Service Note		
Product	Description:	Service note no.
All Manhattan Products + M300	Serrated washer on earth connections.	722 10 1808

JKS020Q1 (Manhattan and Voice Live)

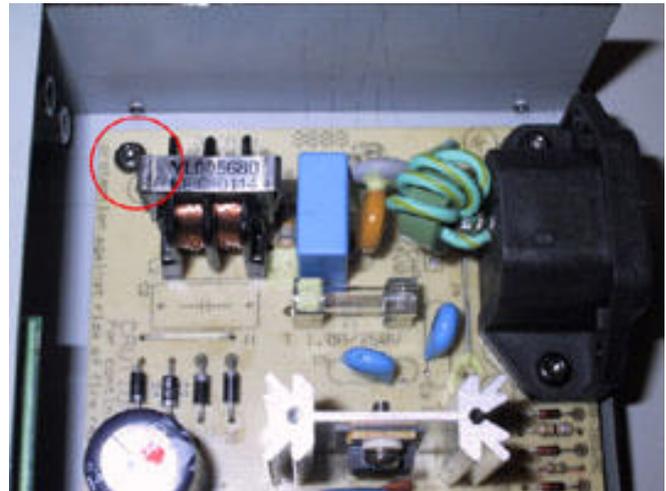
Symptoms: A serrated washer (star washer) must be mounted on the GND connections on all products using PSU type no. JKS020Q1 (Manhattans and Voice Live) and JKS020Q2 (M300).

Remedy: The washer must be mounted according to the photos below:
